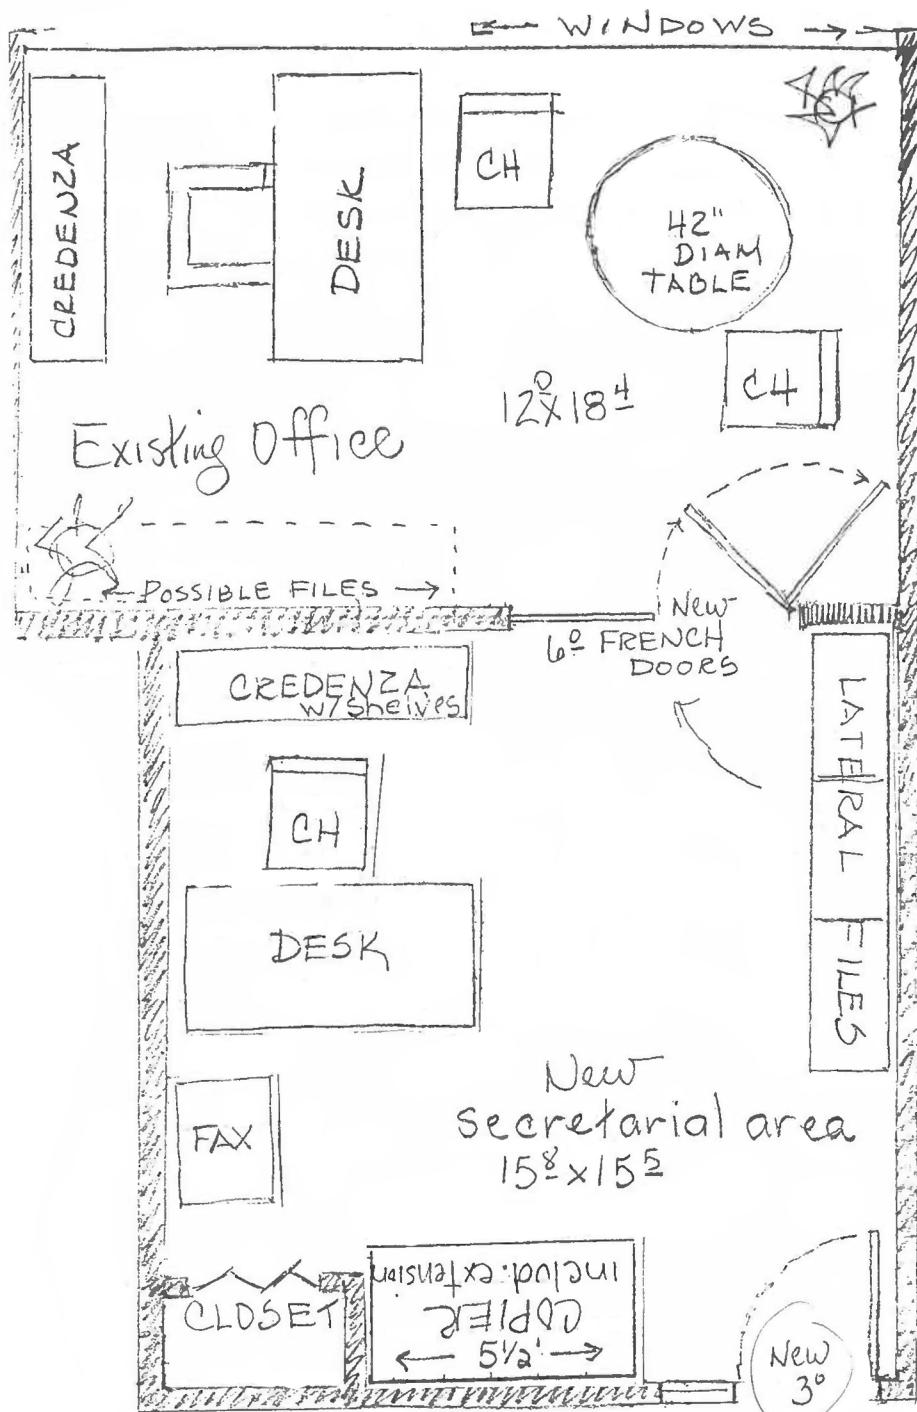
← LEAVE A
STUB WALL
TO ALLOW more than
18" for Lateral Files depth

← French Doors allow
natural light
into reception
Keep left side
closed usually
(maybe 5° would
be adequate?)

← VERIFY WIDTH
FROM CLOSET
TO WALL?

(To Match
existing
Hallway
doors with
side light)
